Traffic Safety Committee

Date & Time:	Thursday – January 25, 2024 6:00 pm
Location:	Sherwood Police Department, Community Room 20495 SW Borchers Drive, Sherwood
Attendees	
T.S.C. Members:	City Staff:
Jason Wuertz-Chair	Dan O'Loughlin-Police Captain
Tiffany Yandt-Vice Chair	Jason Waters-City Engineer
Tony Bevel	Joy Chang-Senior Planner
Dorian Libal	Sabrina Sharp-Admin Assistant II
Richard Amicci (PAB Liaison)

WORK SESSION: SW Sunset Blvd Crosswalk Safety Study Overview & Next Steps

Exhibit 2: Sunset/Woodhaven - Shared Through-Right

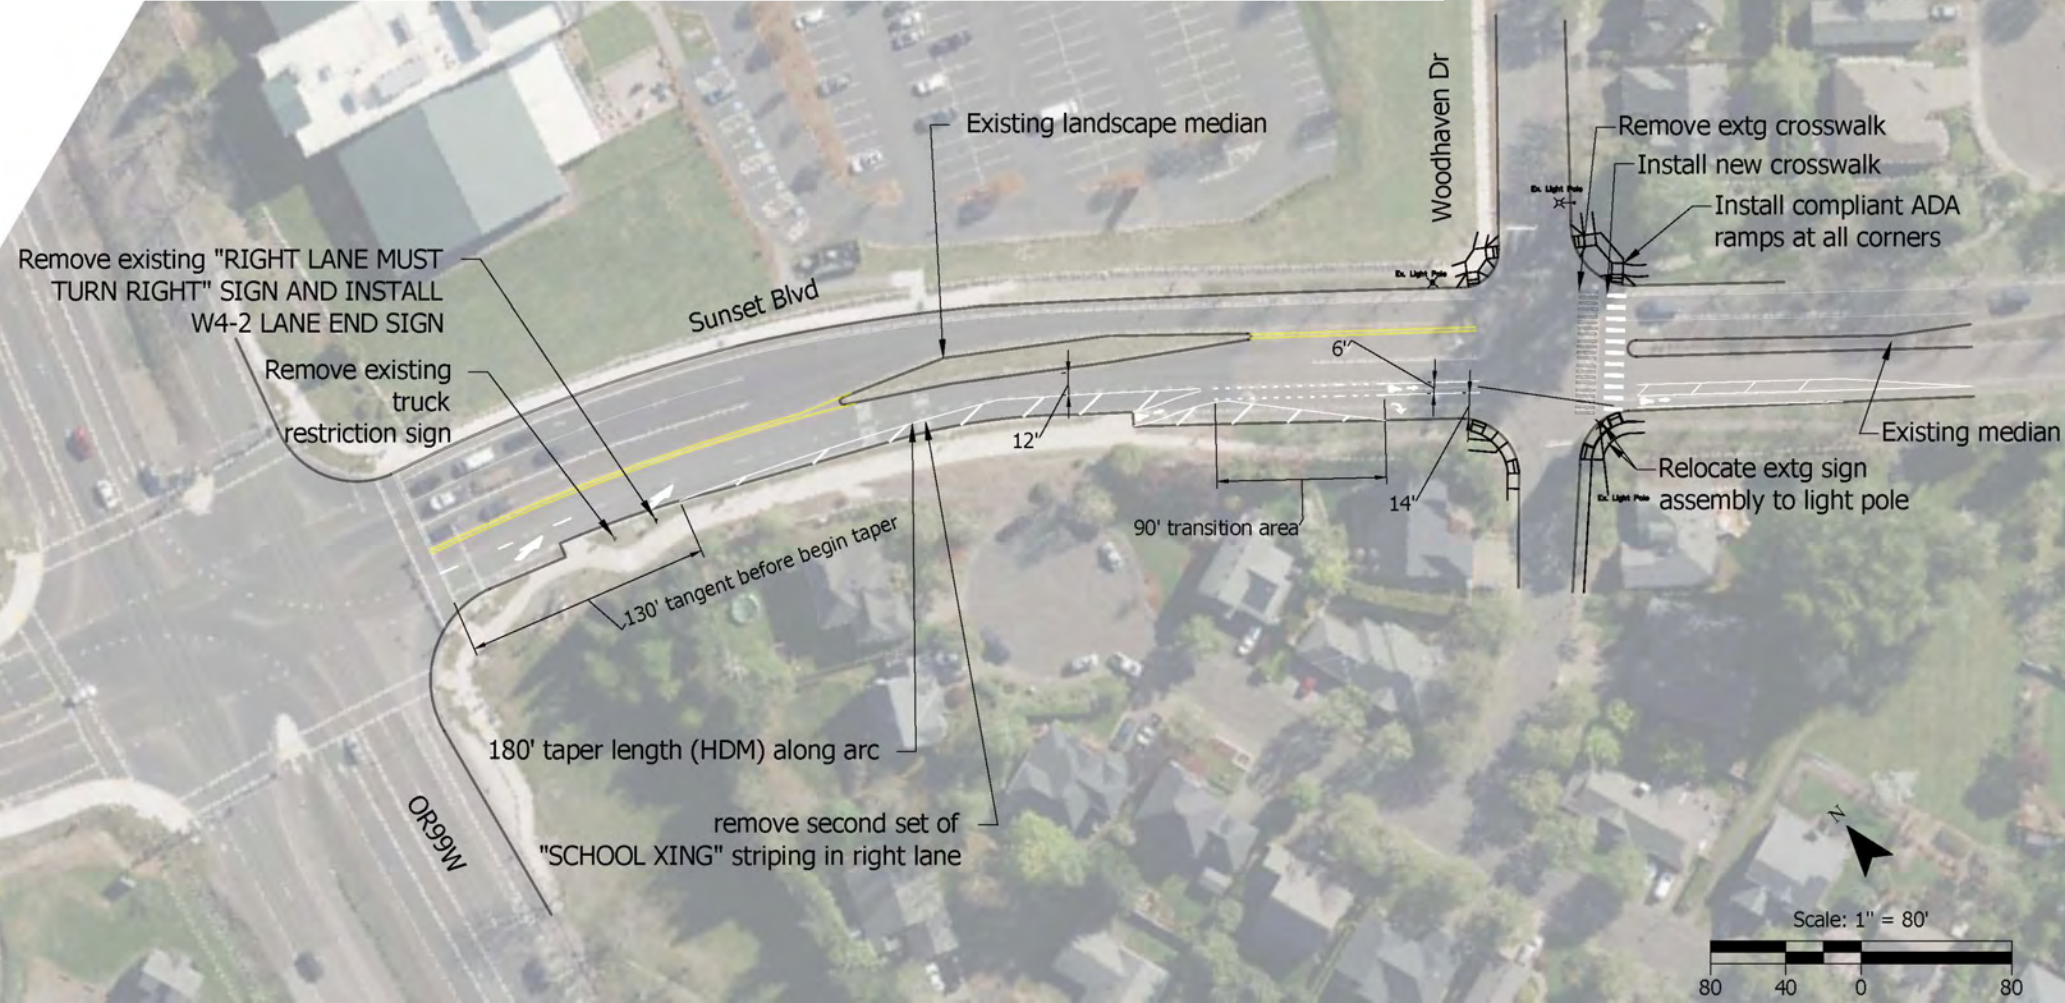
Mr. Amicci asked for clarification on what a hawk signal looks like, and Mr. Libal replied that there is a flashing yellow light on the bottom of the signal, then it goes to solid yellow and there are two solid red lights on the top. Mr. Libal added that these signals are the same cost and infrastructure of a regular traffic signal, but none of the benefits. He indicated that it would be better to put up working signal heads and leave the green light lit until someone needs to cross. Mr. Waters agreed and thought that the City Council also wanted a full pedestrian crossing system as well. He also added that he is hoping to recommend a push button RFB at each intersection and wants to stick with the exhibit 2 layout in the proposed crosswalk study.

Chair Wuertz discussed getting rid of the right lane on Sunset and Woodhaven and tapering it into one lane, which would eliminate vehicles merging at the same time of a pedestrian crossing. He added that there are two different options for this, one with a right turn lane ("Exhibit 1") and one without ("Exhibit 2") and elaborated more on this option. Mr. Waters stated that he would circle back with ODOT, and Chair Wuertz indicated that would not be comfortable making this recommendation, but suggested to place ADA compliant ramps at the corners which would enable staff to place a curb extension at the southwest corner and narrow the crosswalk.

Mr. Amicci asked what time of day the study was done, and if the pedestrian count included children walking to and from school, as well as crossing guards, and other pedestrians who may live in the area. Mr. Waters stated that the study was done during the summer and when school was back in session. Captain O'Loughlin expressed that according to the study, there were 115 pedestrians counted during the morning hours and 156 pedestrians during the evening hours. Chair Wuertz asked if Mr. Bevel or Vice Chair Yandt had any additional comments or thoughts. Vice Chair Yandt stated that she agreed with Chair Wuertz and likes Exhibit 2, the option without the right turn lane.

Mr. Amicci stated that he likes the current flashing signal at the Sunset/Woodhaven intersection and felt that shortening the right turn lane might affect traffic on Highway 99. Chair Wuertz clarified that the right lane would still exist, but there would not be a dedicated right turn lane and would merge into one lane. Captain O'Loughlin expressed that there is not a lot of traffic at location and found it odd that there was a turn lane for such a small area.

A motion was made by Chair Wuertz to recommend the approval of Exhibit 2 of the shared through right on Sunset and Woodhaven, with a potential for a curb extension at the southwest corner, and to recommend rapid flashing beacons at the location. Mr. Amicci seconded the motion and all present committee members voted in favor.

Exhibit 4: Sunset/Timbrel - Remove Sidewalk, Widen Timbrel

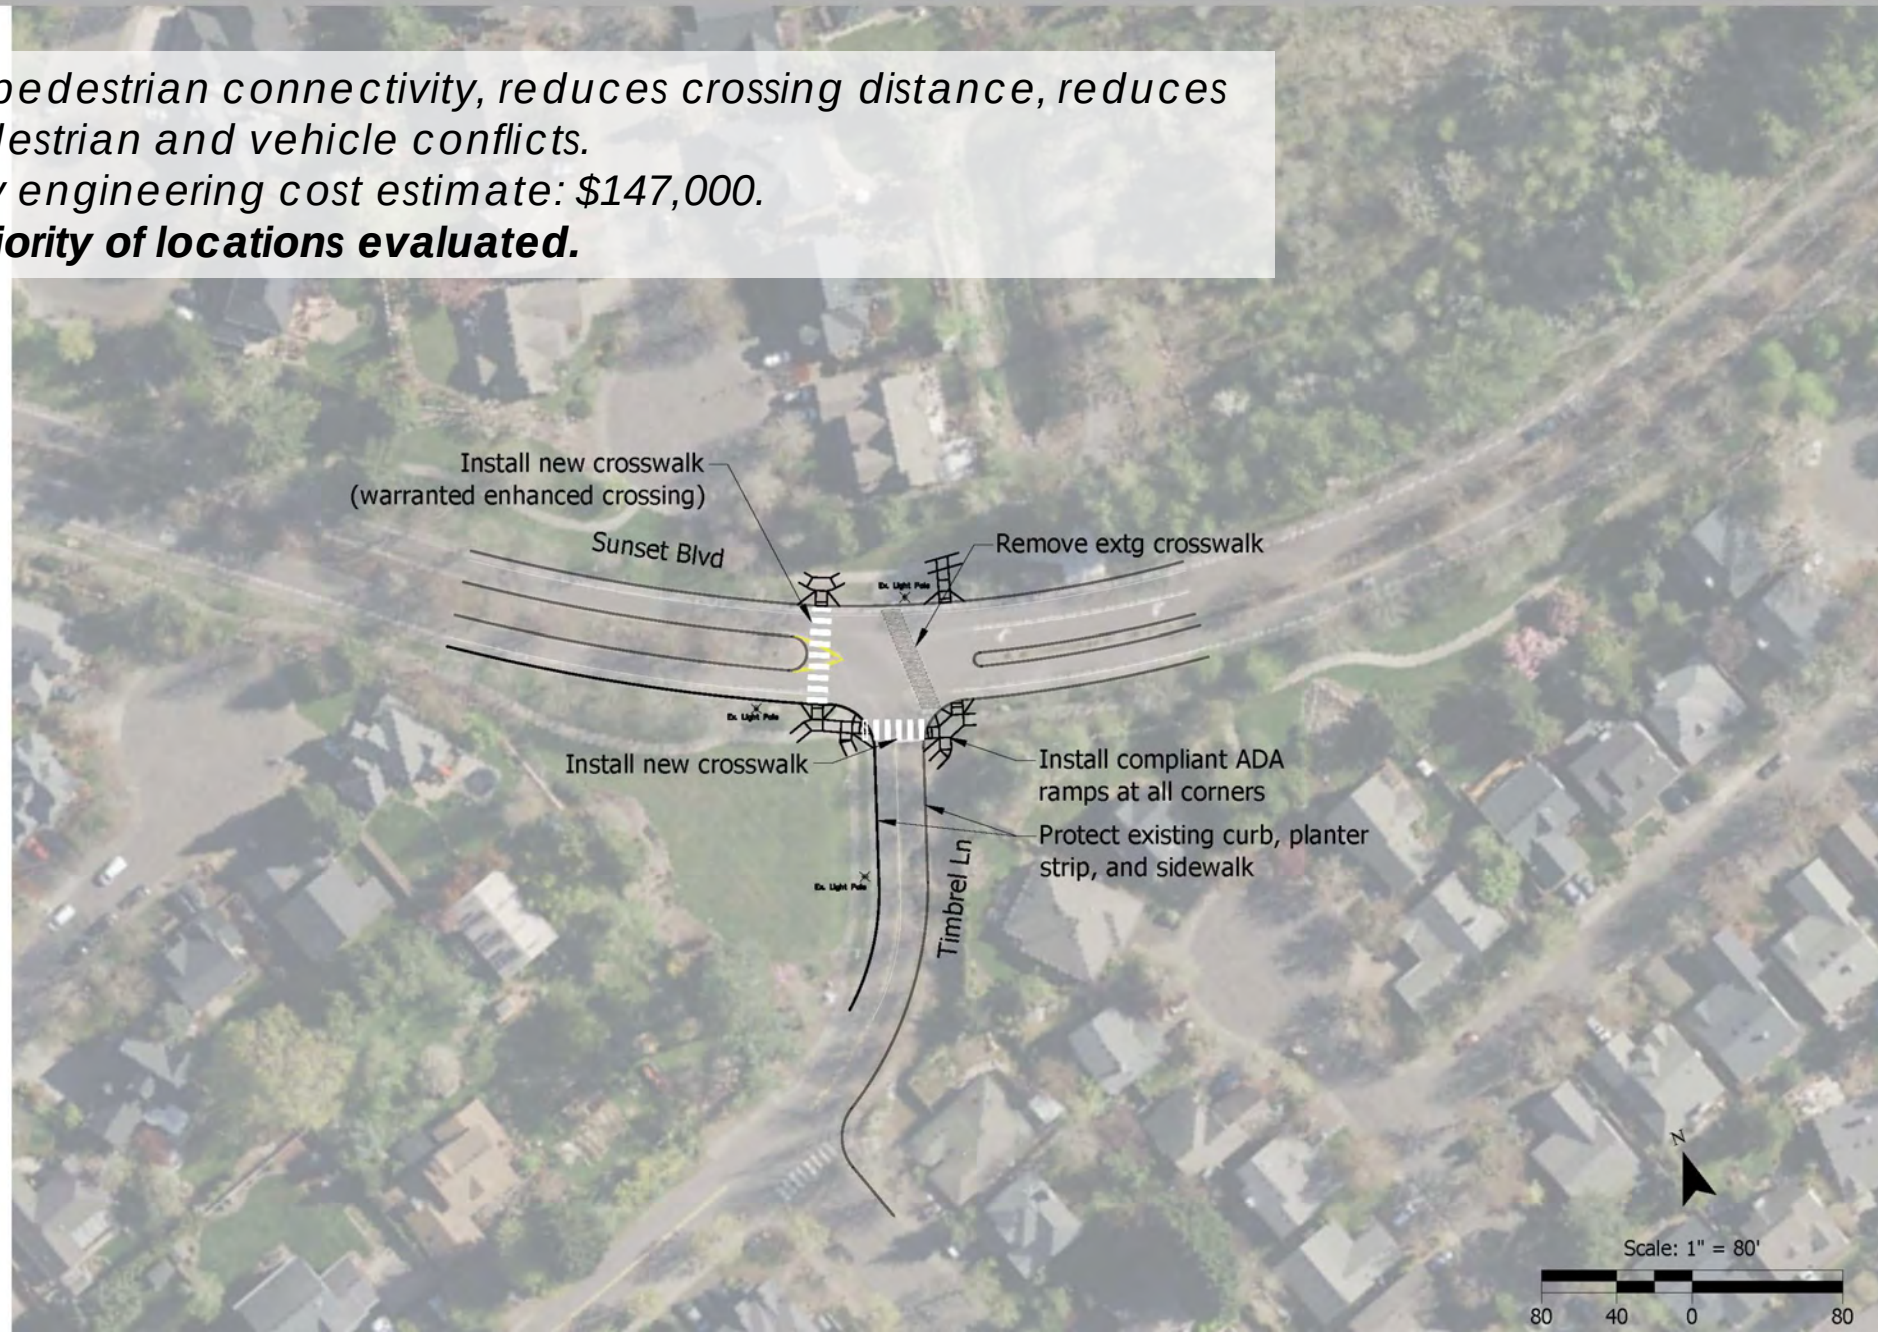
Mr. Libal recommended a rapid flashing beacon, and three arms to control the T-intersection shown in "Exhibit 4". Mr. Amicci expressed that he would rather have a traffic signal, than a roundabout, ("Exhibit 5") and thought that a three-way signal would be beneficial for drivers.

A motion was made by Mr. Libal to straighten the existing crosswalk, have a power RFB, not solar, and to have a long-term study done for a full signal intersection at Sunset and Timbrel. The motion was seconded by Mr. Amicci and all present committee members voted in favor.
